Public comment on the Phillips 66 Santa Maria oil terminal proposal

Beverly J. Goldrup to: p66-railspur-comments 11/25/2014 11:03 AM
Sent by: Sierra Club <information@sierraclub.org>
Please respond to "Beverly J. Goldrup"

Figure 1. Railroad Accident Rate 2004 – 2014

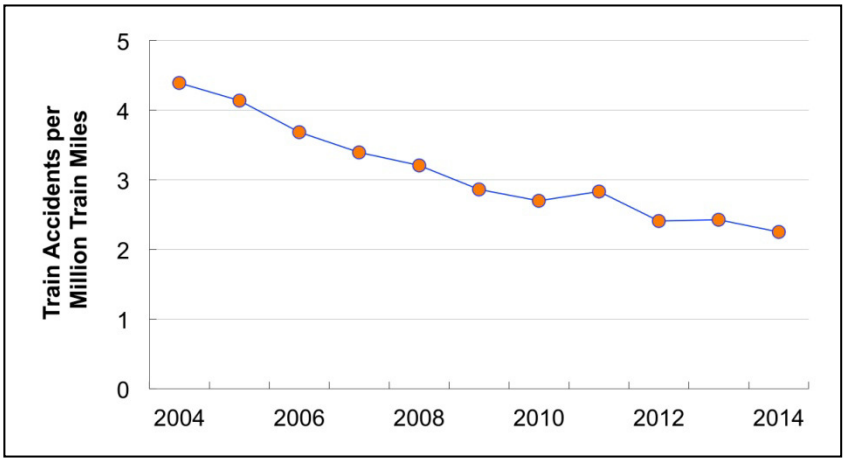
Phillips 66 in no way can guarantee the safety of these trains. They have stated as much publicly. That should concern each of you. Communities and emergency responders along the rail route are not prepared for these heavy, dangerous trains. Their current safety standards are not adequate to protect the public. The recirculated draft EIR dangerously misinforms the public because it uses outdated data and does not adequately assess the risks of an oil train disaster involving an oil train carrying millions of gallons of explosive crude oil. GOB-03

The railroad accident rate has been steadily trending downward for over a decade. The accident rates in the past few years were the lowest since the FRA started recording the data in the mid-1970s. In the period from 2004 to 2014 the rate declined by 49% (almost half) (see Figure 1 below). Most derailments receive little or no attention from the public or media. Railroads are required by regulation to report all accidents that exceed a certain monetary threshold in damage to track, signals and rolling stock (currently $9,600). Proper estimation of train accident rates involves analysis of all accidents, divided by the total amount of traffic. The reason that some perceive an increase in the railroad petroleum crude oil accident rate is because of the more than 50-fold increase in this traffic since 2009. Estimates are that 233,698 tank cars of crude oil were moved by rail in 2012. This increased to over 435,000 tank cars moved by rail in 2013 (the full year of data is not yet available for 2014). With this increase in crude by rail traffic, the derailment and spill probability data would suggest that multiple crude by rail accidents would happen each year.
